FINAL DRAINAGE REPORT

MERIDIAN ROAD & BENT GRASS MEADOWS DRIVE

Engineering Review

**EPC Planning & Community
Development Department**

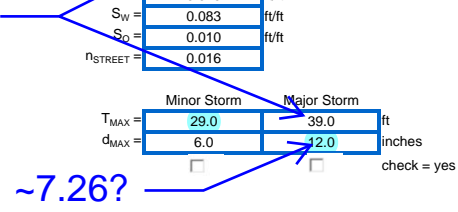
Replace street capacity calculations with revisions.

26?
